RESOLUTION HOLDING HEARING ON REQUEST FROM RIVER POINT WEST, LLC FOR APPROVAL OF PUD FINAL DEVELOPMENT PLAN “SLATE AT GRAY’S LANDING” FOR PROPERTY AT 400 SOUTHWEST 11TH STREET

Communication from the City Plan and Zoning Commission advising that at their April 1, 2021 meeting, the following action was taken regarding a request from River Point West LLC (owner) represented by Will Anderson (officer) for review and approval of a PUD Final Development Plan "Slate at Gray's Landing" for development of the senior housing project proposed for 400 SW 11th Street.

Request from River Point West LLC (owner) represented by Will Anderson (officer) for the property located at 400 SW 11th Street		File #		
		10-2021-7.60		
Description of Action	Review and approval of a PUD Final Development Plan "Slate at Gray's Landing" for development of the senior housing project.			
PlanDSM Future Land Use	Current: Downtown Mixed Use. Proposed: N/A.			
Mobilizing Tomorrow Transportation Plan	No planned improvements.			
Current Zoning District	Slate at Gray's Landing Legacy "PUD" Planned Unit Development.			
Proposed Zoning District	N/A.			
Consent Card Responses	In Favor	Not In Favor	Undetermined	% Oppositio

2 Clubhouse East Elevation
1/8" = 1'-0"

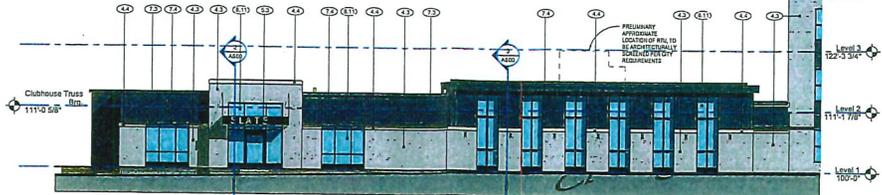
3. Patio fencing for all ground floor units shall include a gate.
4. Provision of additional architectural interest for the portion of the east façade of the clubhouse that contains the entrance to the satisfaction of the Planning and Urban Design Administrator. This could include, but is not limited to, additional material variation, vertical emphasis and/or articulation. (10-2021-7.60)
